LEReC-I (1.6-2MeV): Gun to dump SRF gun used as a gun

Revised Cooling Sections

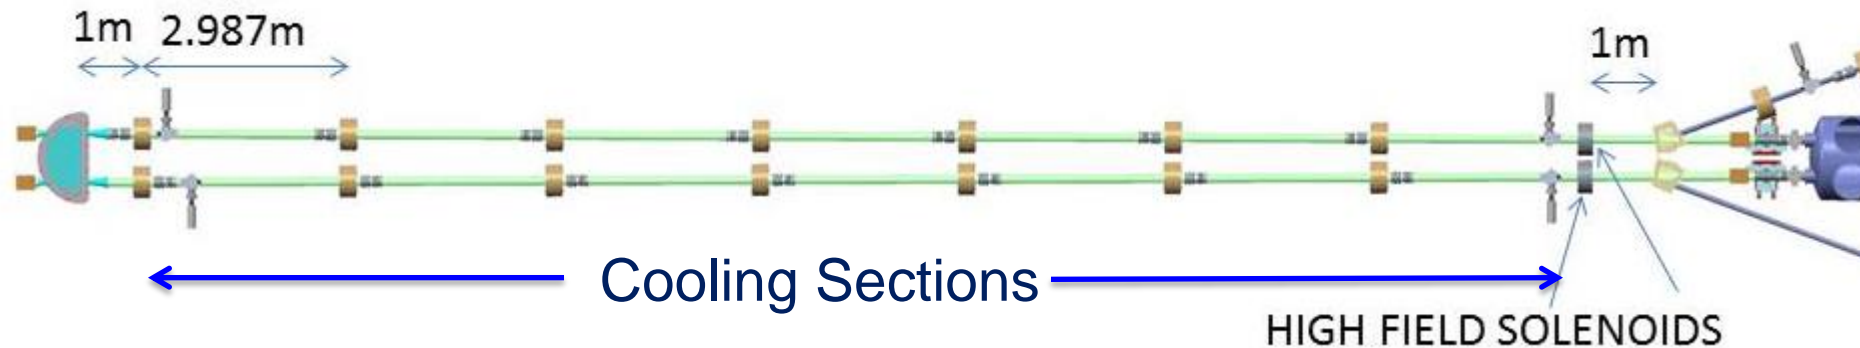
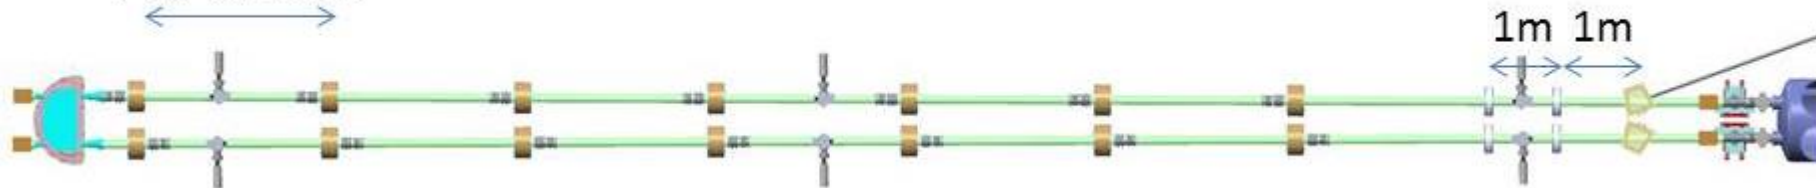
Eliminate 2 of 4 high field (matching) solenoids & PS.

Keep 2 high field H & V correctors in matching solenoids (& PS)

Stretch cooling sections: same number of low field (compensating) solenoids, correctors, PS's, and BPM's.

High Field Solenoid for LEReC (using solid conductor)

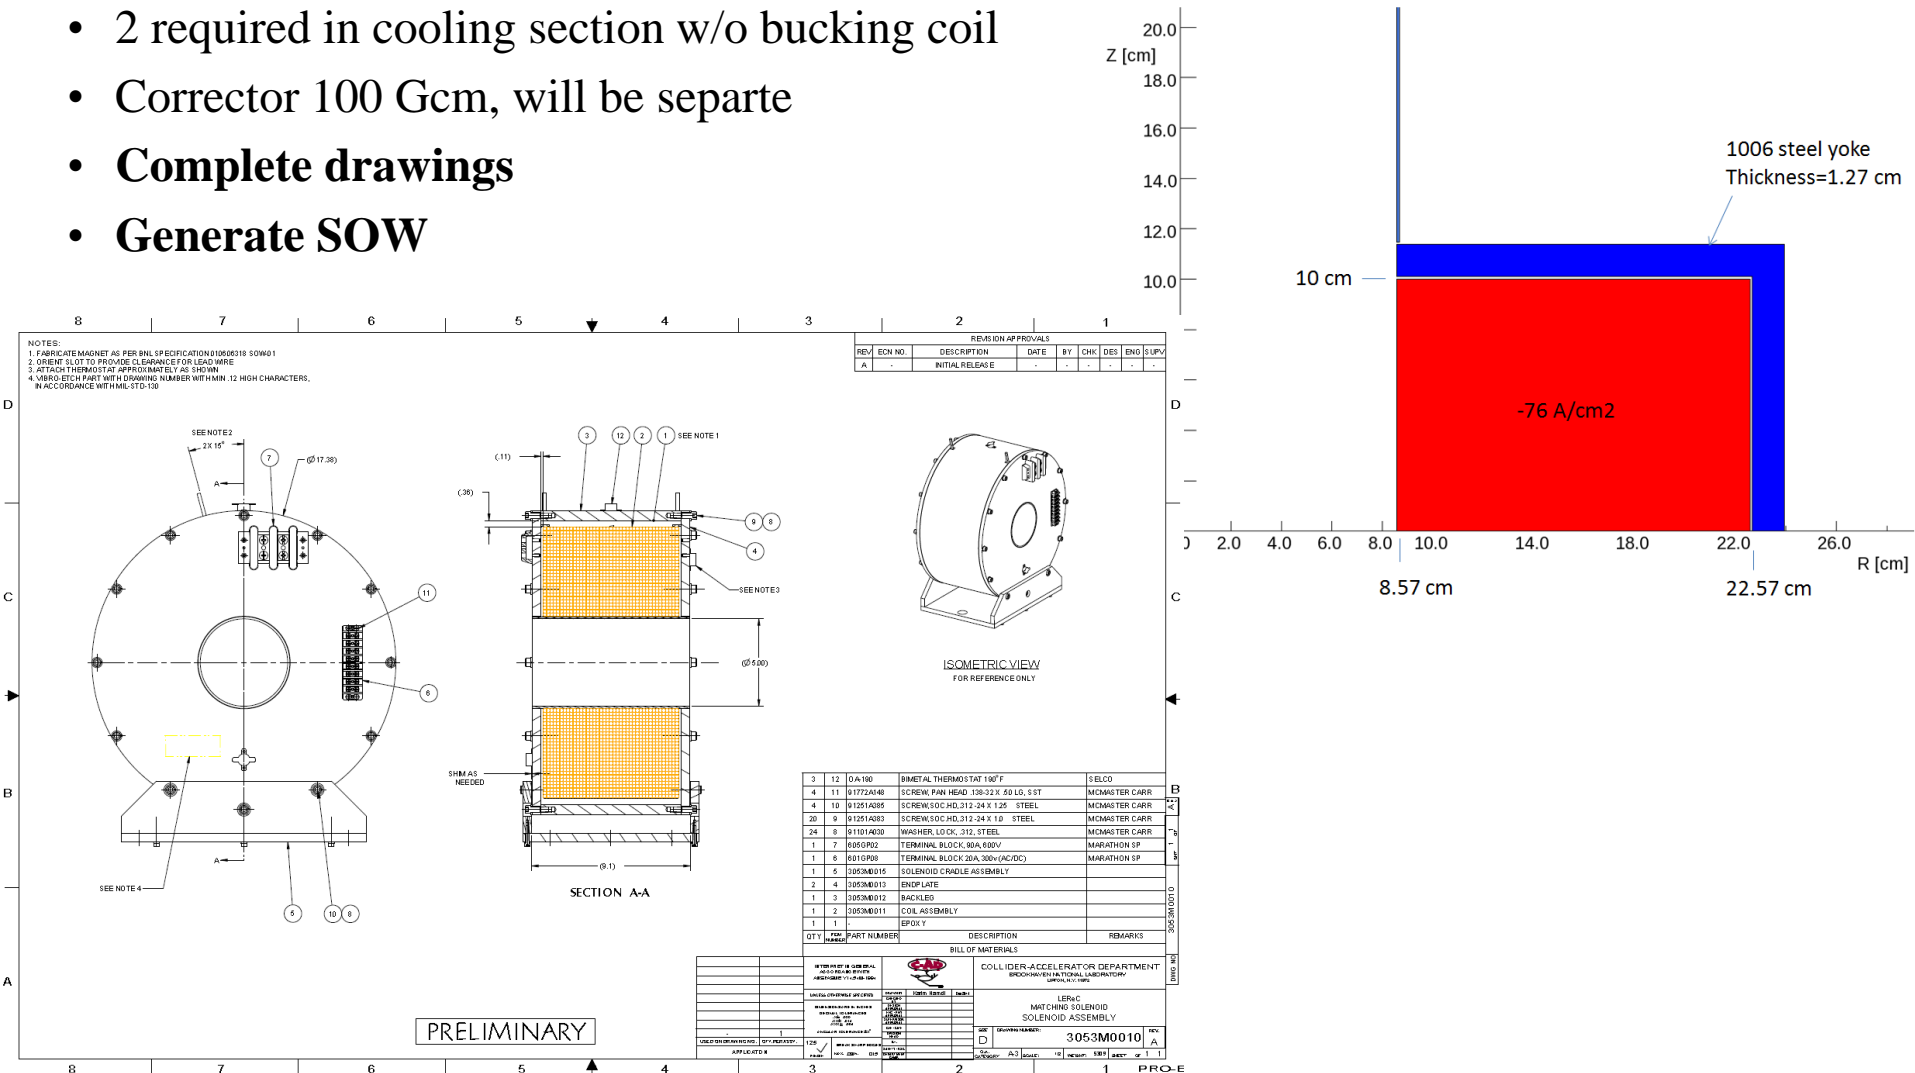
- 2 required in cooling section w/o bucking coil
- Corrector 100 Gcm, will be separate
- **Complete drawings**
- **Generate SOW**

180° Dipole Magnet

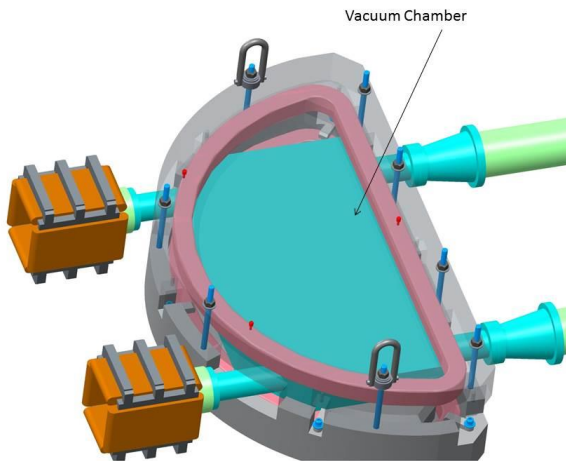
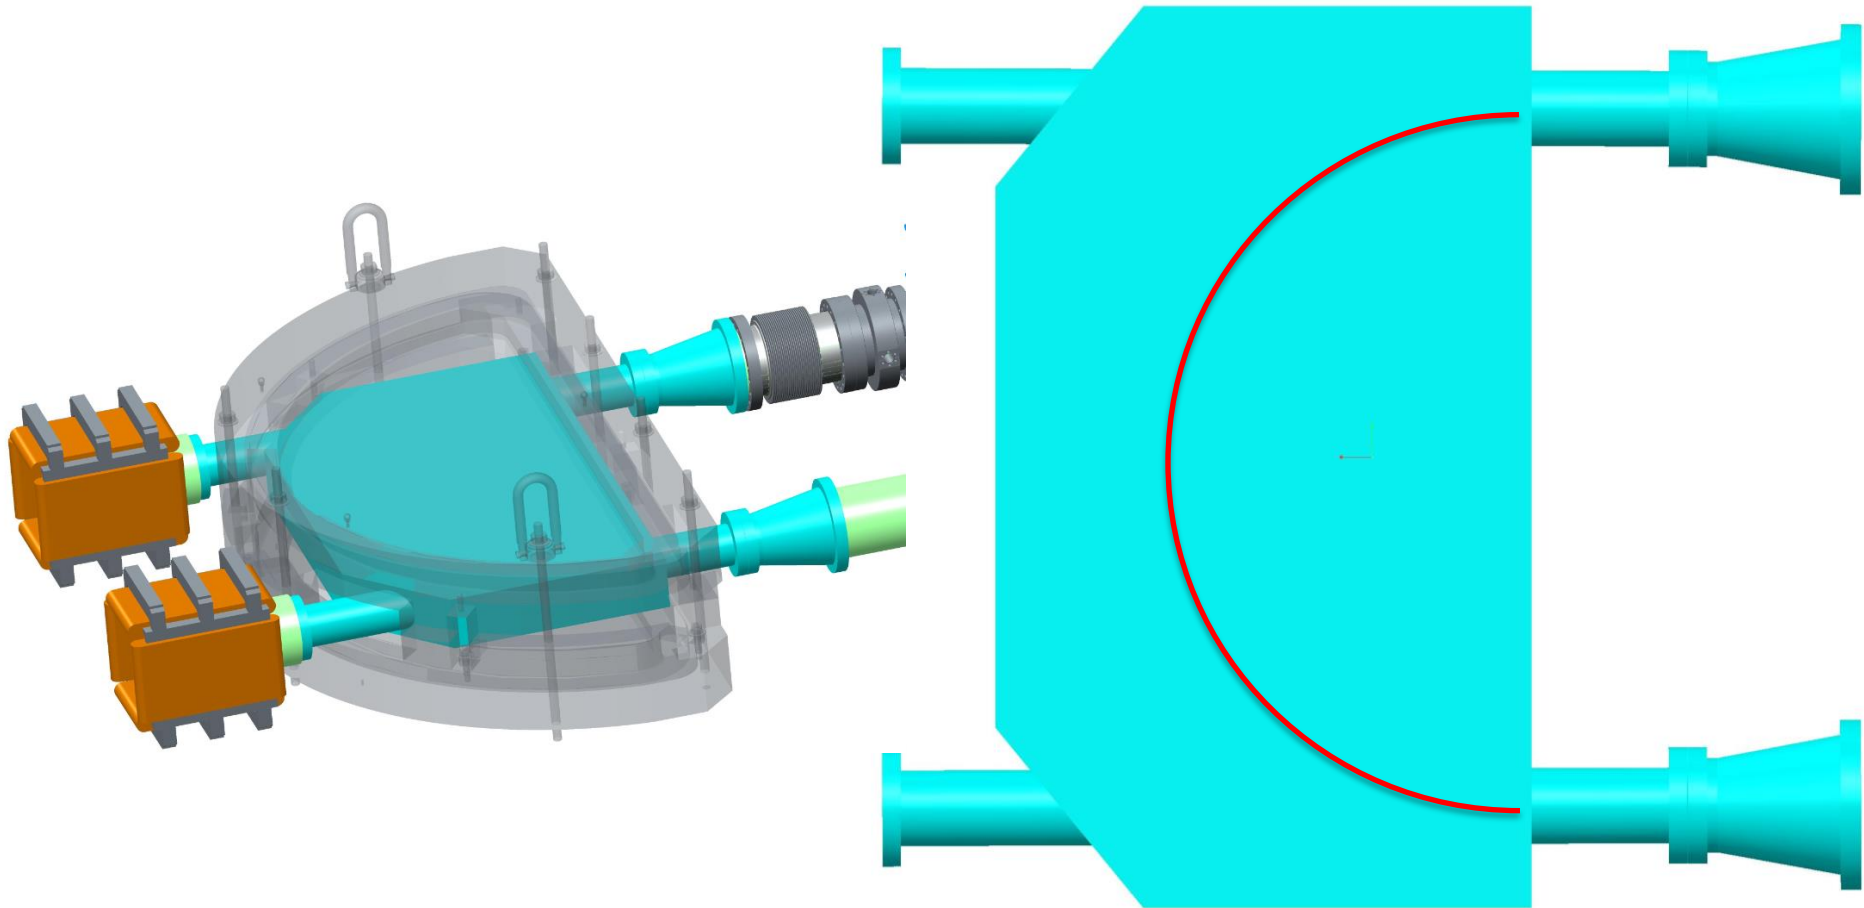
Large open 180° vacuum chamber: are there beam impedance concerns? Should the electron beam path be shielded?

Similar issue for 21° chamber?

Beam Dump Line to Vacuum Valve:

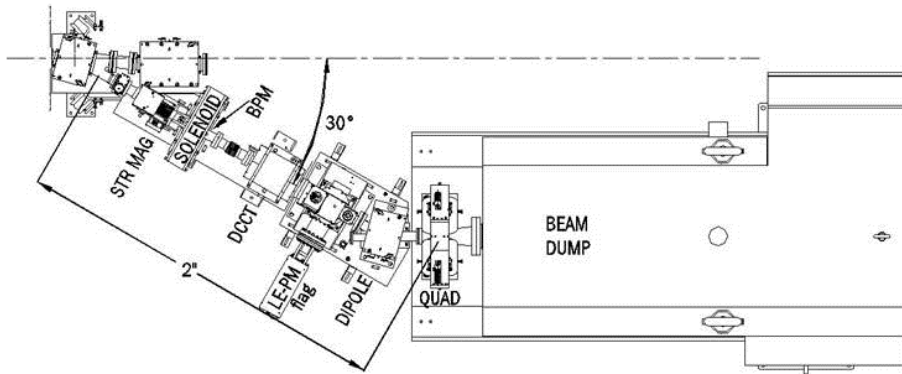
- (4) 20o dipoles 10 cm aperture
- Or
- (2) 20o dipoles 10 cm aperture
- (2) 20o dipoles 6 cm aperture ??

What components can we take from ERL extraction line? To be determined.

Cooling Sections

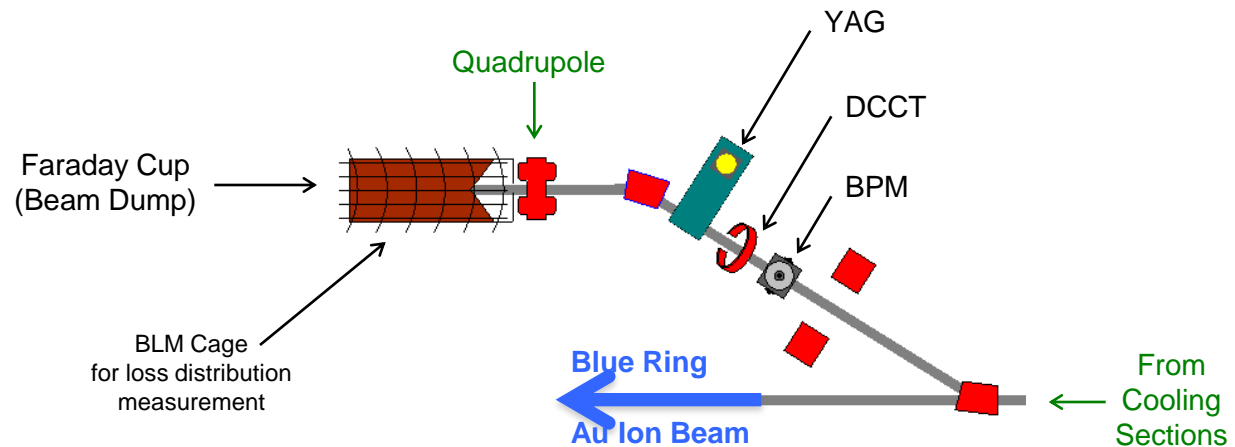
Questions & concerns include:

- Energy Slits are 4 & 7m away from 180 deg. dipole. They can move to 4 & 1m away if one slit is built into a 3-position profile monitor. This would require a special design for the profile monitor – but this is a well known technique.
- Did we decide on 6 YAG Profile monitors AND 2 Flying Wire Scanners in the cooling section, or did the two Flying Wire Scanners replace the two middle YAG Profile Monitors?
- Do we really want the Halo Scrapers and the diagnostic beam line after the 5-Cell or should they be after the SRF Gun?
- Are all solenoids in the transport spaced 3m apart?
